**SUBJECT – REQUEST FOR FURTHER INFORMATION – WONGAN HILLS LIMITED  
RESOURCE CONSENT APPLICATIONS CRC224237 AND CRC224238**

**RFI Response – Wongan Hills Limited Resource Consents CRC224237 and CRC224238**

**Figure 1: Internal Dimensions of the Barn Compost Pit**

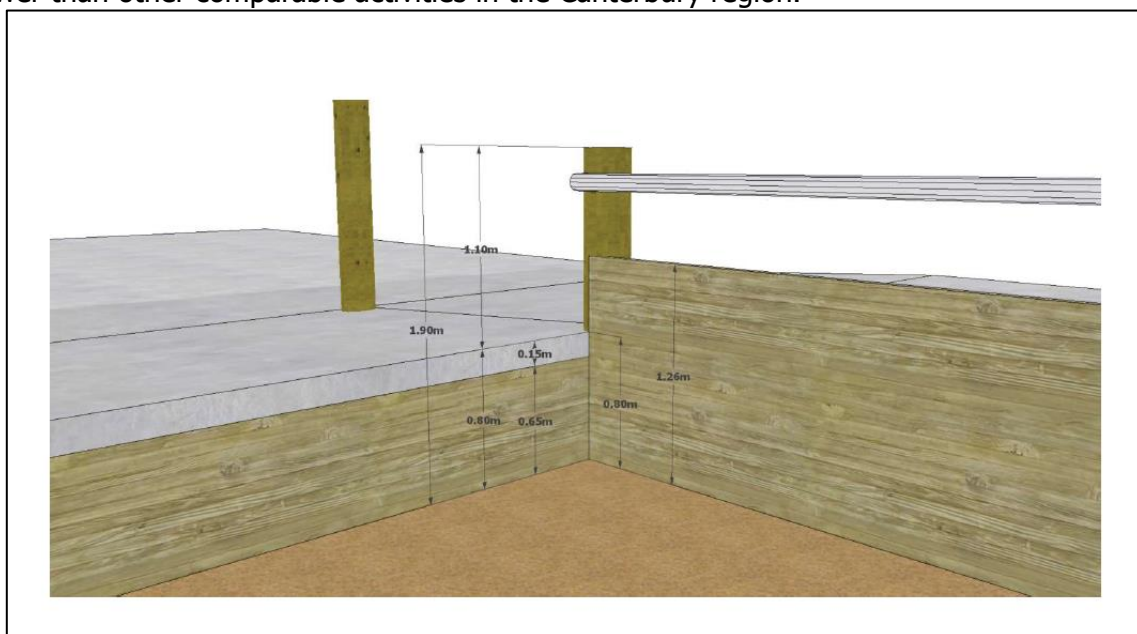
**Item 3: Entry of water into the barns**

*The RFI response states that the base area will be lined with approximately 12 m wide heavy duty plastic liners which are overlapped by 0.3 to 1 m and tapped to seal. Can you please provide additional information on how you will ensure these are not damaged during removal of compost material and how the 'intactness' of the liners will be monitored over time to ensure they are still functioning as required (i.e. not ripped, fractured, broken down over time etc). Should the barn be inundated with flood water, will these liners ensure that the barn remains impermeable to discharge of water via ground? I acknowledge that during flood events the ground can become saturated so thinking in reverse, during flood events would there be any risk of water entering the barn from the ground up*

Given the above, the flood risk is completely avoided (even in a 200-year ARI flood event) by the elevated height of the barns. The lowest level of the barns is at the southern entrance apron of Barn four. The concrete level is 5.785 m and rises by 0.5 % over the 240 m length to 6.785 at the northern end. The other barns are progressively higher in elevation, with Barn one having the lowest level of 6.235 m.

The concrete entrance is lower than the side walls, which are a further 460 mm above the compost and entrance apron level. **The barns are above a 200 yr. flood level by 185 mm, 335 mm, 485 mm and 635 mm at the finished entrance levels above for the barns.** The height of the barns above the existing ground surface is the first mitigating factor to avoid inundation of the barns. The external walls are 460 mm higher (Figure 1).

The design of the barn mitigates the potential for flooding from the Kaituna River to enter the buildings and compost.
